Public Works Department.

The Estimate under
review amounting
to Rs. 1064 provided
for remodeling the
lightning conductor
of No. 1 Magazine
attached to the
Arsenal at Tollymore

Approving & transferring
letter from the Insp^r Genl
of Ordnance submitting
for disposal an estimate
amounting to Rs 1064 for
remodelling the Sighting
Conductors of No 1 Magazine
attached to the Bellary
Arsenal.

Report to accompany estimate
for remodelling Lightning Rods of
Magazine No 1 Bellary Fort.

Nº 1
MAGAZINE

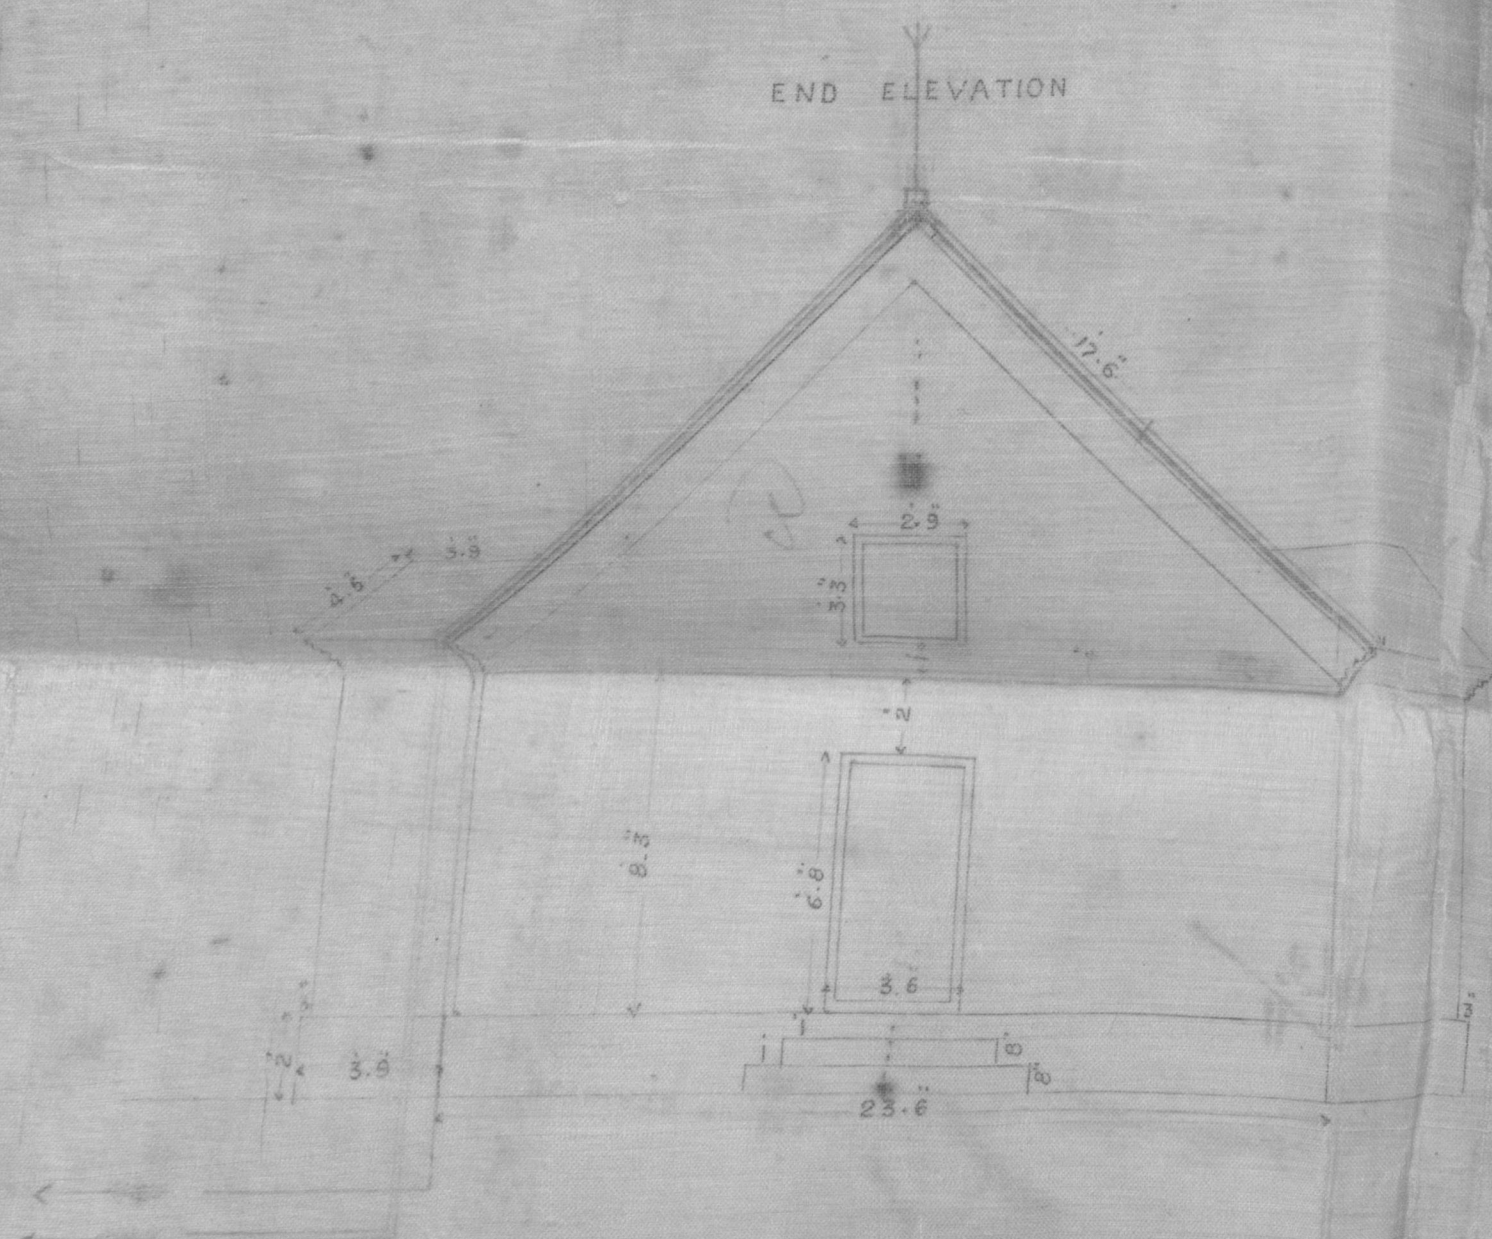
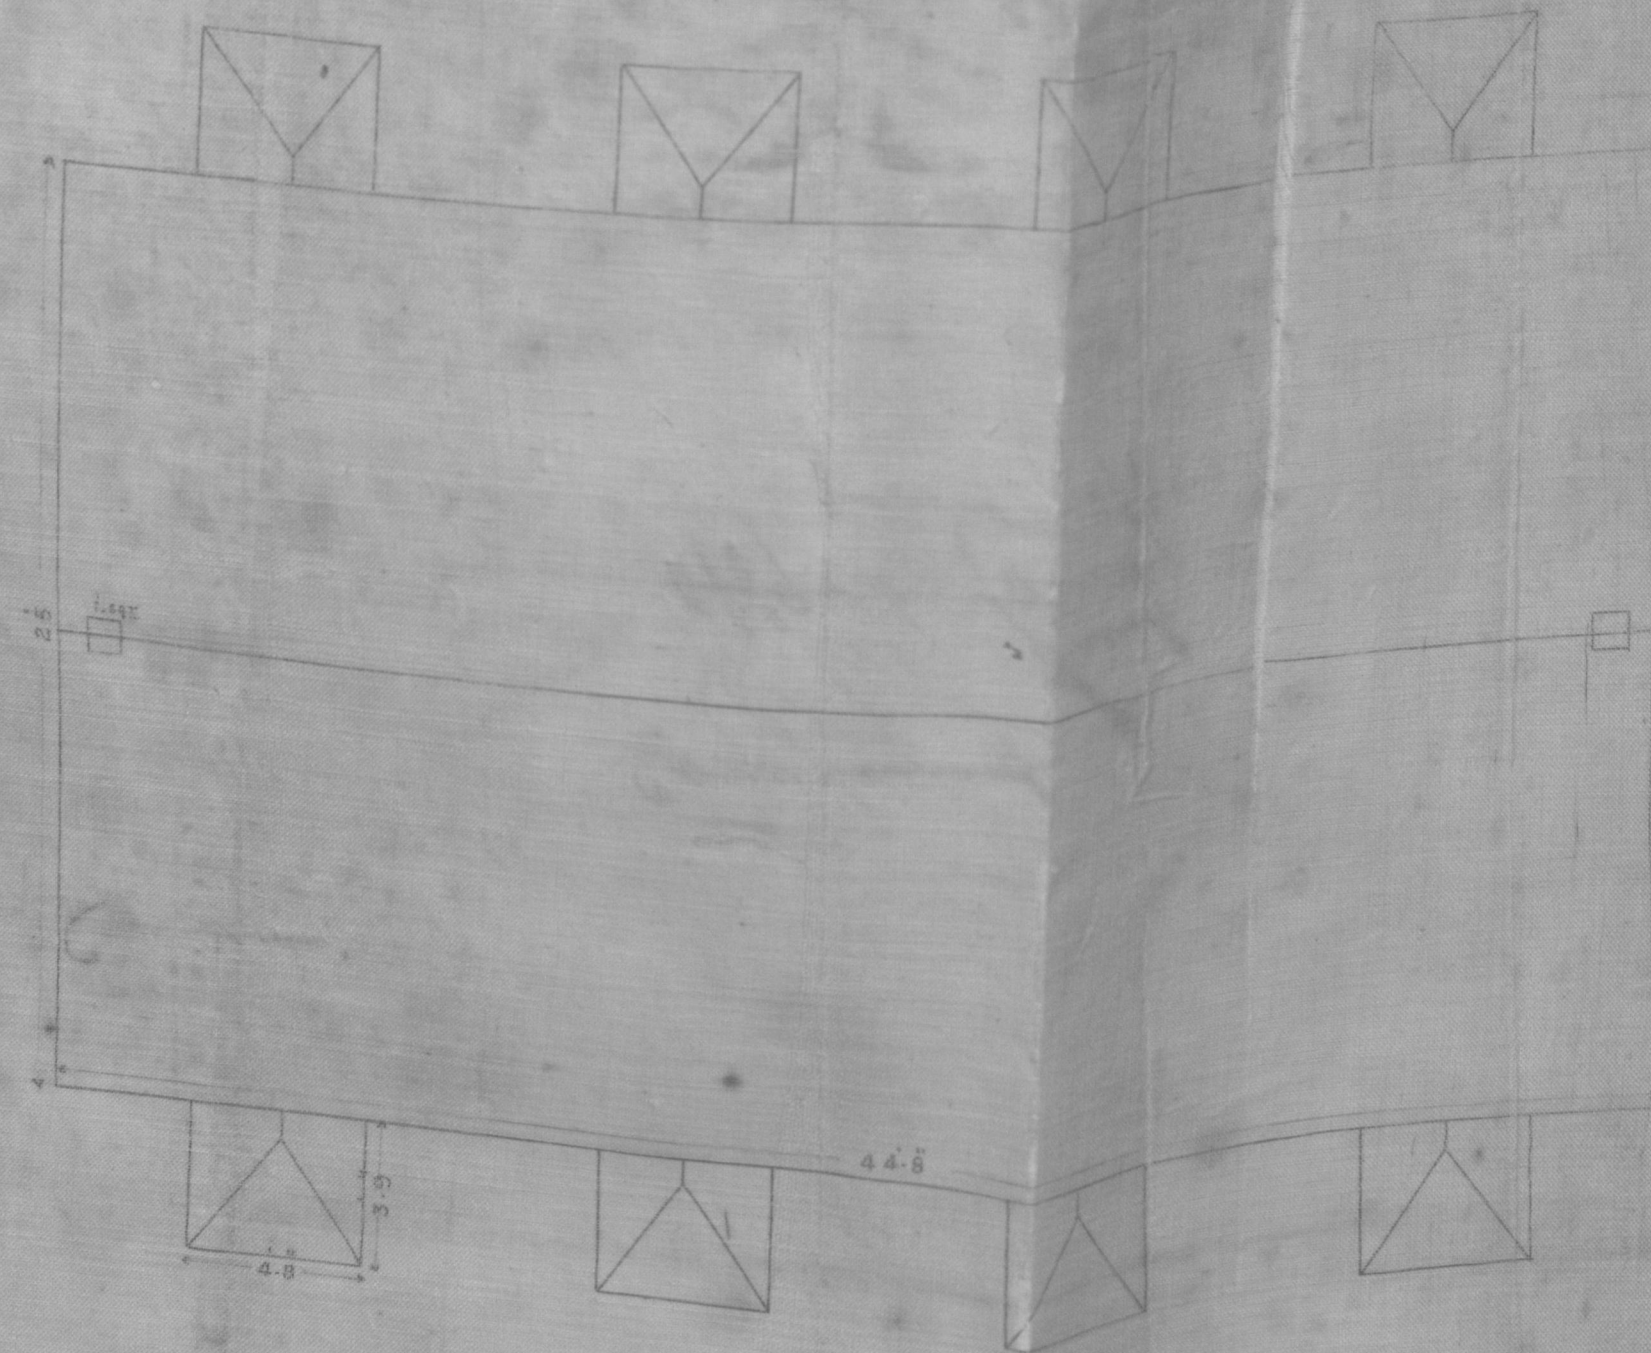
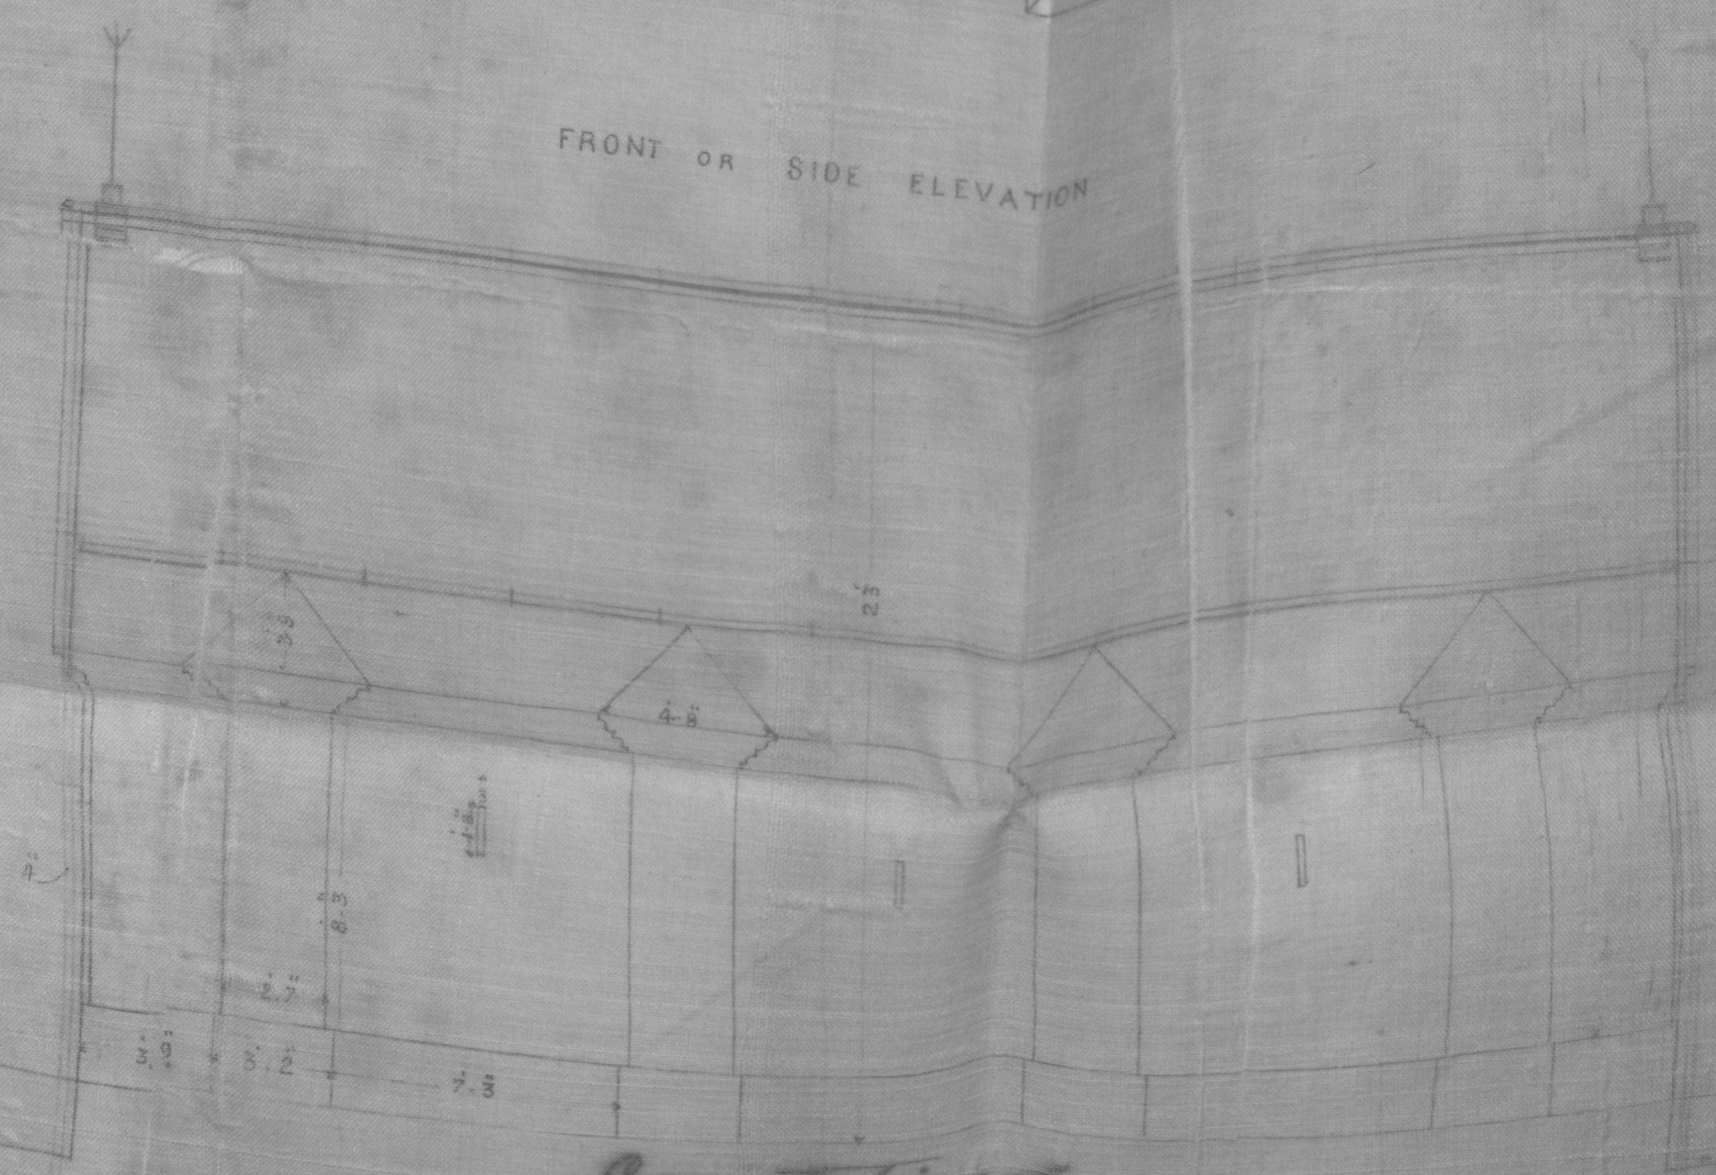
The S.T. should have
the earth connections
examined, and then
test the whole system;
probably a small
sum spent in repairs
would make the
existing conductors
quite efficient

2. It does not seem
necessary to incur the
expense of providing an
entirely new arrangement
of lightning conductors
for this magazine. The
Supdy: Engr. should have
the earth connections
examined, and the whole
system then tested.
It is probable that
a small sum spent in
repairs would make
the existing conductors
quite efficient.

I have the honor to report
that I have had the earth con-
nections of No. 1 magazine in the
Post at Bellary opened out and
tested and I find ^{them in} ~~there is~~ no
much better order than I anti-
cipated that I accept your sug-
gestion to retain the present
conductor and simply repair
it. The only thing I propose to
do in addition to repairs is to
bury a mass of old iron beneath
each earth plate as recommended
in Rule XVIII Regulations of the Royal
Engineer Department issued with army
circulars of 9 November 1887, the

the soil being very hard and dry.
An estimate not exceeding Rs 200
classed as Repairs will now be
sent to the Ordnance Department
for countersignature and the
work will be carried out at the
same time as the periodelling
the conductor of the 2 magazine
viz in February 1899 as already
arranged with the Ordnance Officer
Bellary.
